21154 PCI-to-PCI Bridge

Specification Update

July 2004

Order Number: [278295-017](#)

Figure 1. S_Clock Multiplexer Workaround Circuit for Errata 6.

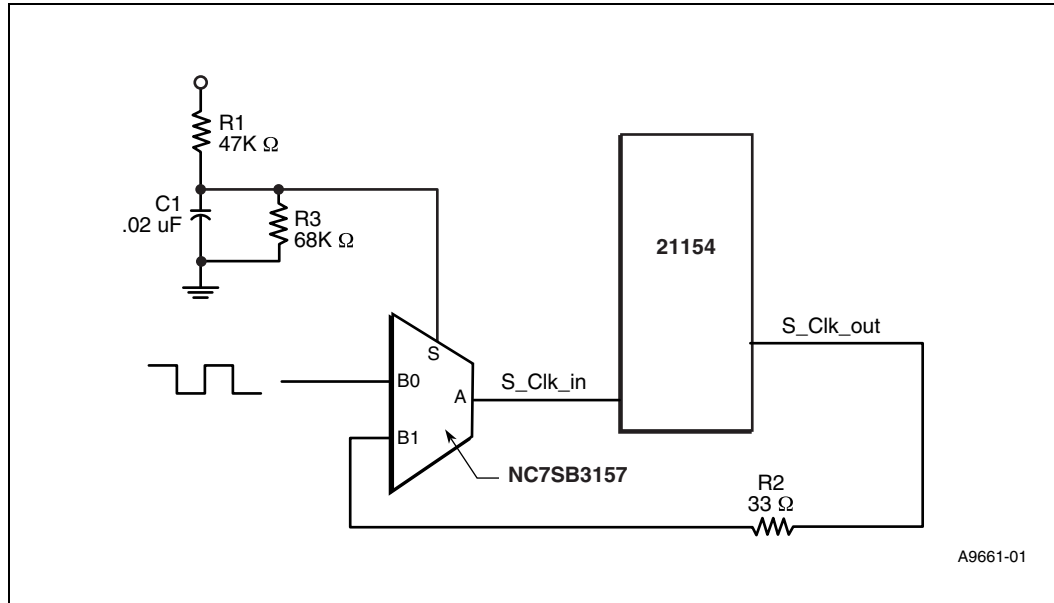
6. Secondary Clocks Outputs s_clk_o<9:0> May Not Start-up Properly Under Some Conditions

Problem: This problem has been found on the 21154AC and 21154BC. Under repeated and frequent power cycling, the secondary clock circuits may not power up in the proper state, resulting in the device not coming out of reset after power up.

Implication: In a system with a 21154AC or 21154BC that has one of its s_clk_o<9:0> outputs fed back to provide the s_clk, it is possible that the s_clk_o<9:0> output clocks will be driven and remain low, keeping s_rst_l asserted, during system power up.

Workaround: Two workarounds are provided for this errata:

1. [Figure 1](#) illustrates the first recommendation - a circuit where an on-board pulse source is gated via the B0 input of the multiplexer to the S_Clock_in pin of the 21150.

At time 0, the S input of the multiplexer is low, allowing pulses from the on-board pulse source, connected to the B0 input, to be provided to the 21150 S_Clk input pin. When the time determined by the R/C network is satisfied, the S input pin will be in a logic High state. The multiplexer will then shut off the input pulse from S0 and will direct the S_Clock_out pulses via the B1 multiplexer input, into S_Clock_in

The values used for the R/C network should be selected to allow a minimum of 2 pulses to be delivered to the 21150 after Vdd has reached 3.0V at a frequency not to exceed the appropriate PCI component. i.e. 30 ns for a 33Mhz bridge. These values should be chosen based on the rise time of the power supply and the frequency of the on board pulse source. The values given for R1, R3, and C1 are for example purposes only.

Note: The NC7SB3157 2:1 Multiplexer / Demultiplexer Bus Switch used in this example has a maximum propagation delay of 800ps that should be taken into consideration when matching trace lengths of the clock lines to avoid introducing excessive skew in the clocks. All S_Clock etch lengths must be matched to within 2ns @ 33Mhz or 1ns @ 66Mhz. The addition of this circuit requires that the etch length for the S_clock_in signal be reduced to compensate for the 800ps delay.

Figure 6. Removal of Pull-Down Resistor for JTAG Testing

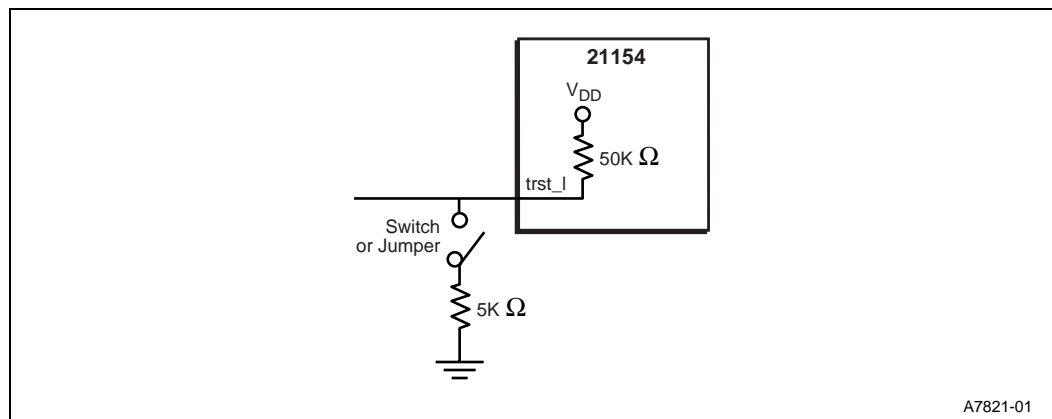
9. Section 6.3.1, Signal `trst_l` Pull-Down Resistor, New Section

A 5 K Ω pull-down resistor is required on `trst_l` for normal PCI-to-PCI bridge operation. However, some JTAG test results may be inconclusive if the 5 K Ω resistor remains in the circuit. To obtain accurate JTAG results, Intel recommends one of the following solutions:

- Verify that the JTAG test equipment, after driving `trst_l` low to reset the TAP controller, constantly drives `trst_l` high during JTAG tests. If this signal is not constantly driven high, the 5 K Ω resistor will pull the signal to a low state.
- Remove the 5 K Ω resistor during JTAG tests. This resistor must be installed during normal PCI-to-PCI bridge operation.
- Design external circuits with a switch or jumper to isolate the 5 K Ω resistor during JTAG tests (see Figure 6). This switch must enable the resistor during normal PCI-to-PCI bridge operation.

Figure 19 Example of GPIO Clock Mask Implementation on the System Board

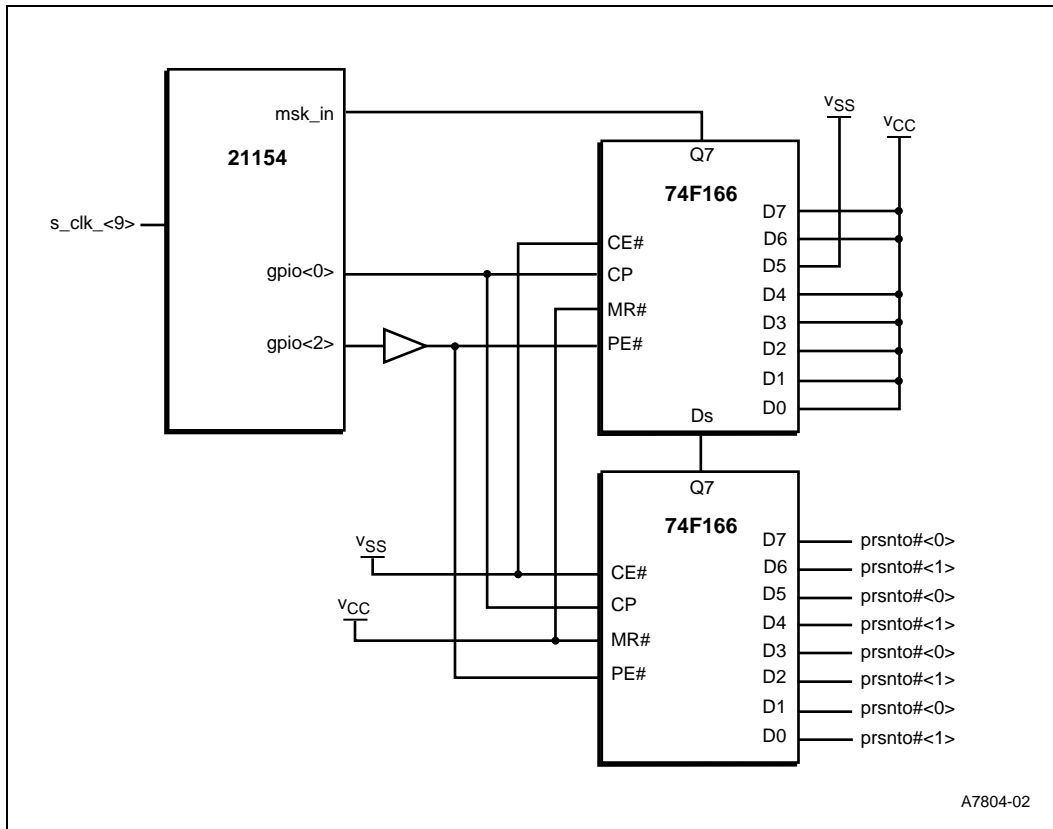
12. Section 10.2, Secondary Clock Control, Figure 19

This figure now appears as follows:

Figure 20. Clock Mask and Load Shift Timing

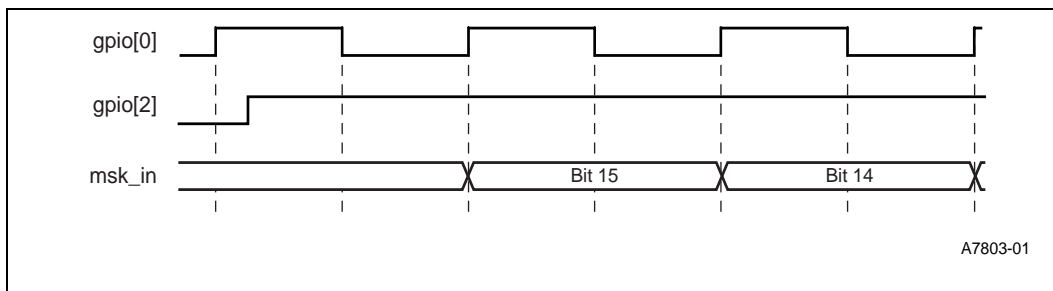
13. Section 10.2, Secondary Clock Control, Figure 20

This figure now appears as follows:

Figure 21. Clock Mask and Load Shift Timing

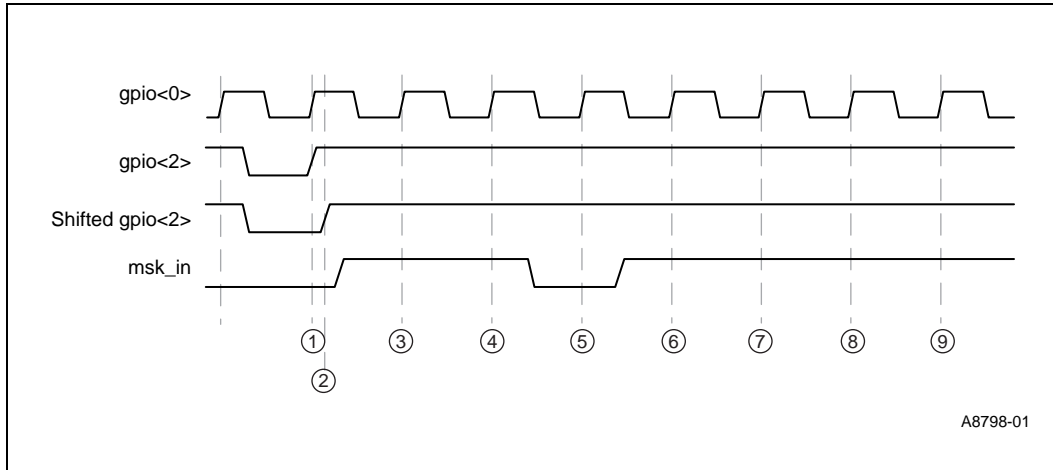
15. Section 10.2.1, Mask and Load Shift Timing Events for 66 MHz Operation

The following list provides the timing sequence for 66 MHz operation for an example circuit as shown in [Figure 19](#) and the timing diagram in [Figure 21](#).

1. The **gpio<2>** original coming from the 21154 does not provide 3ns setup time needed to provide the parallel load enable **PE#** of the 74F166.
2. The shifted **gpio<2>** is delayed by ~9ns to provide ample setup time to enable the parallel of the shift register connected to pin 15 of the 74F166.
3. Bit 15 input **D6** of the shift register is pulled high, to Vcc.
4. Bit 14 input **D7** is pulled high, to Vcc. These signals are not used internally in the 21154.
5. Bit **13 s_clk_o<9>** is a feedback to the 21154 **s_clk_o** input. To enable **s_clk_o<9>** in all cases the **D5** input of the shift register is grounded, to Vss.
6. Bit 12 **s_clk_o<8>** is disabled.
7. Bit 11 **s_clk_o<7>** is disabled.
8. Bit 10 **s_clk_o<6>** is disabled.
9. Bit 9 **s_clk_o<5>** is disabled.

Figure 3 Example of GPIO Clock Mask Implementation on the System Board

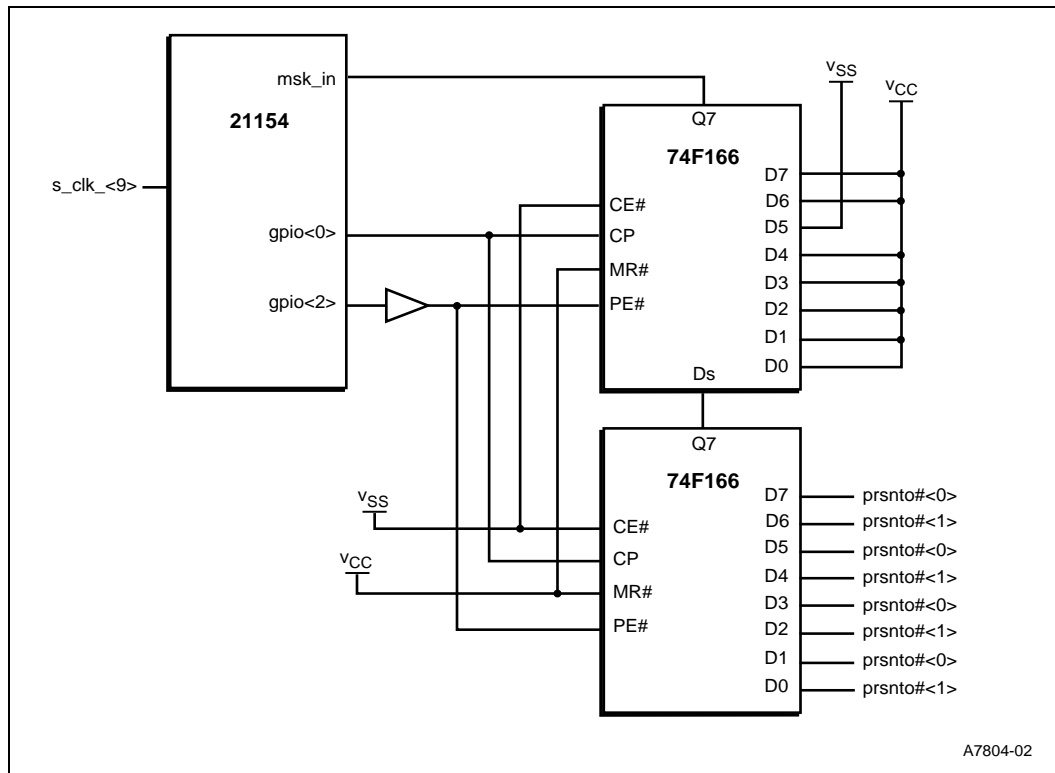
18. Section 4.4.1, Serial Clock Mask Shift, Figure 3

Figure 3 has been updated as follows:

Figure 4. Clock Mask Load and Shift Timing

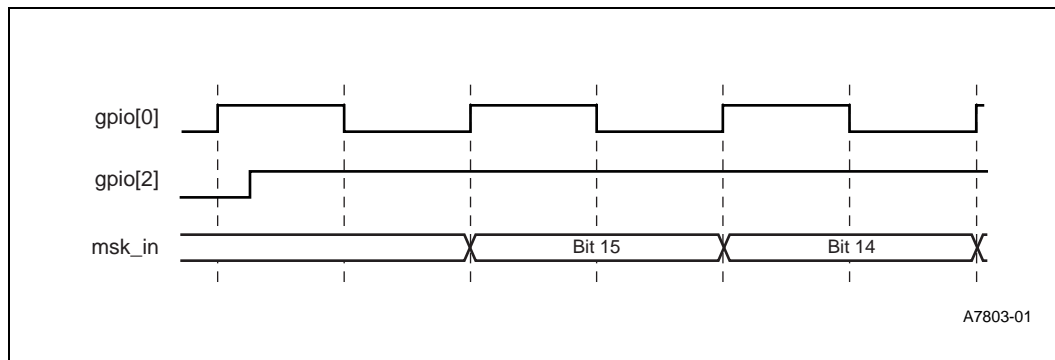
19. Section 4.4.1, Serial Clock Mask Shift, Figure 4

Figure 4 now appears as follows:
